Address: 2915 Robinson Street

"PCD File No. PPR242"

DRAWN BY: O.E. WATTS DATE: 11-6-23 DWG. NO.: 23-5981-02 SURVEYED BY: ESW, DJW, 11-6-23	APPROVED BY: PROJ. NO. DWG.	REVISIONS	PROJECT 2915 W. ROBINSON ST. LOT 1, CHICO SUB. COLORADO SPRINGS	PREPARED BY: OLIVER E. WATTS CONSULTING ENGINEER COLORADO SPRINGS	PROJECT 2915 W. ROBINSON ST. LOT 1, CHICO SUB. COLORADO SPRINGS	SHT. NO. <b>DEVELOPMENT PLAN</b> 1 OF 1
---	-----------------------------------	-----------	--	--	--	---

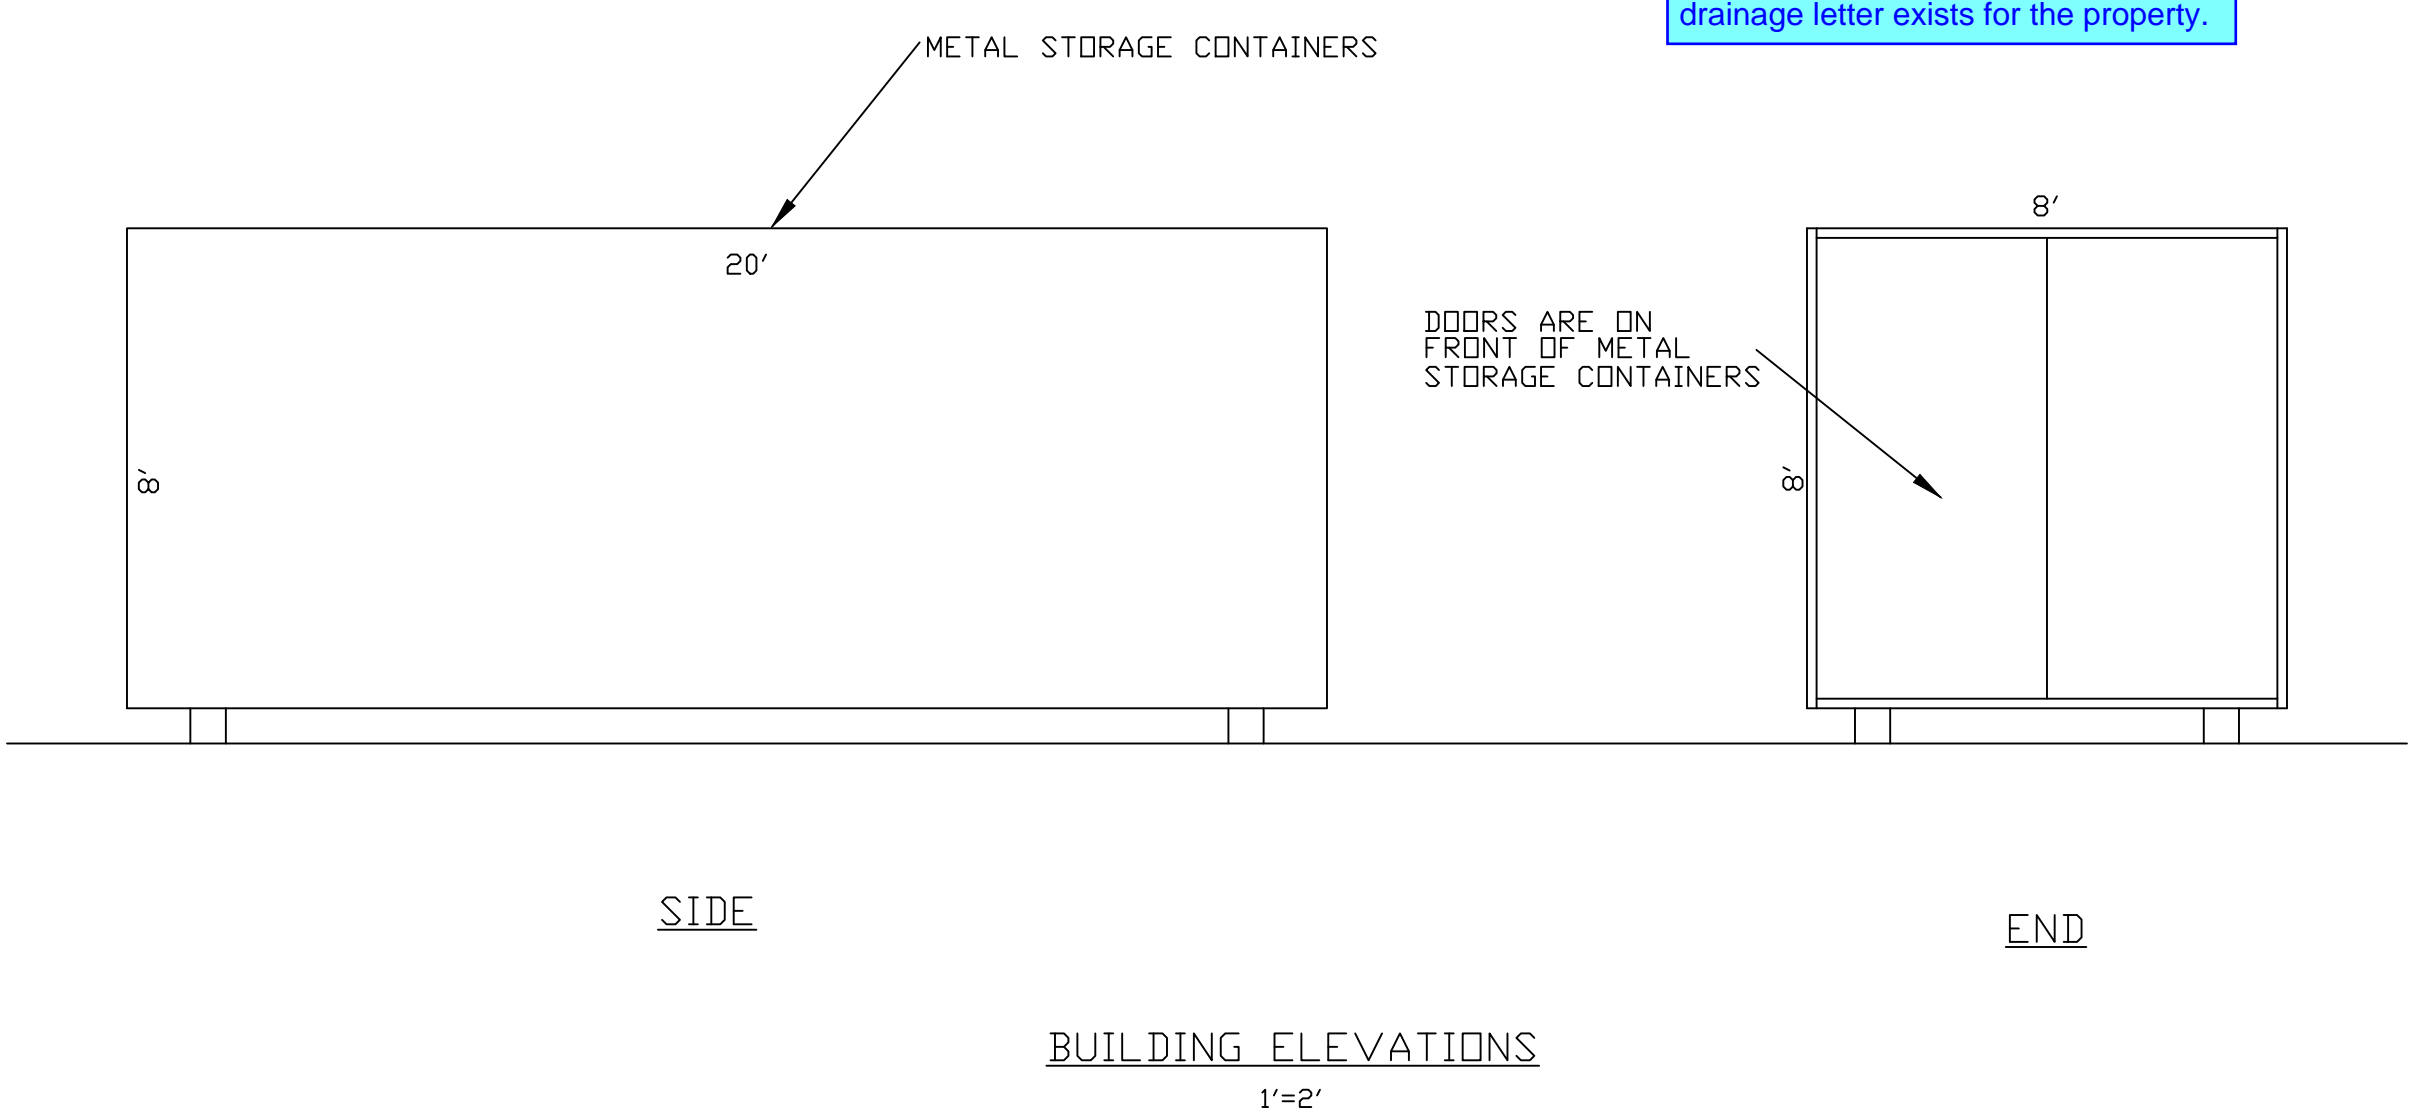
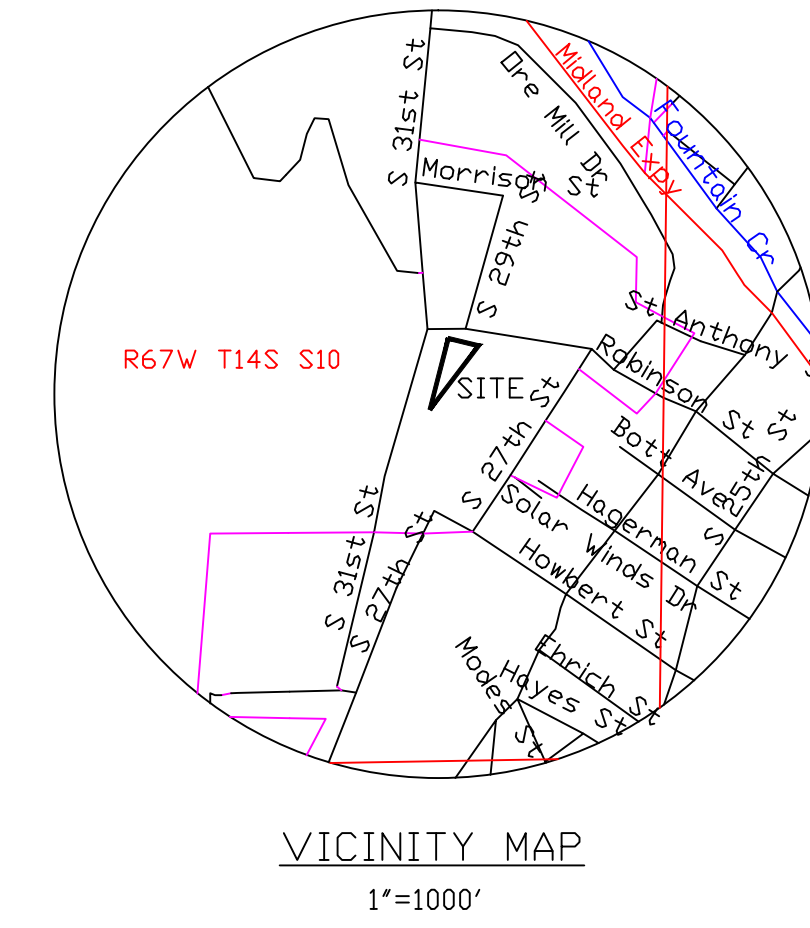
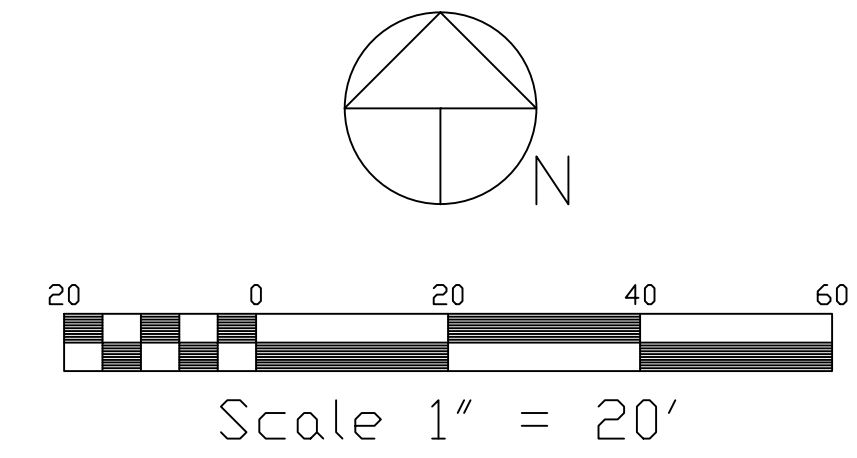
Please indicate the following on the Site Plan:  
 - points of ingress and egress  
 - traffic circulation  
 - parking  
 - location of garbage receptacle  
 - location of existing lighting

These structures must be moved out of the 5' drainage and utility easement as structures are not allowed to encroach on said easements. If you cannot move the structures and you wish to vacate the easements, you can accomplish that via a plat amendment (vacation).

All storage containers will have to be moved outside of the drainage easement. Please update site plan.

Please provide PCD file number of the approved drainage letter or copy. Staff could not locate drainage letter. Alternatively, revise statement if no drainage letter exists for the property.

Please depict where these spaces will be on the site plan

Verify this calculation. The square footage and acreage do not seem to match.

Change to 645 S 31st St. per Enumerations comment
